Project	IEEE 802.16 Broadband Wireless Access Working Group < http://ieee802.org/16 >	
Title	MS network entry Flow Charts for non-transparent RS with Centralized Scheduling	
Date Submitted	2007-07-05	
Source(s)	Masato Okuda Fujitsu Laboratories LTD. Kamikodanaka 4-1-1, Nakahara-ku Kawasaki, Japan. 211-8588	Voice: +81-44-754-2811 E-mail: okuda@jp.fujitsu.com
Re:	IEEE802.16j-07/19, "Call for Technical Comments Regarding IEEE Project 802.16j"	
Abstract	This contribution proposes MS network entry procedure Flow Charts in non-transparent Relay Station systems.	
Purpose	To propose text to describe MS network entry in non-transparent Relay Station systems	
Notice	<i>This document does not represent the agreed views of the IEEE 802.16 Working Group or any of its subgroups. It represents only the views of the participants listed in the "Source(s)" field above. It is offered as a basis for discussion. It is not binding on the contributor(s), who reserve(s) the right to add, amend or withdraw material contained herein.</i>

MS network entry Flow Charts for non-transparent RS with Centralized Scheduling

[Figure-X-1 MS CDMA ranging - RS](#)

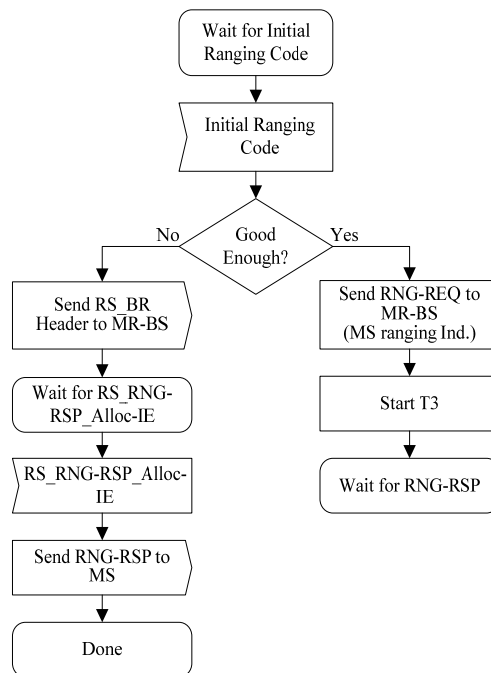
Insert the following figures after the table 199b in the 6.3.9.16.2.1 (Non-transparent RS with Centralized Scheduling):
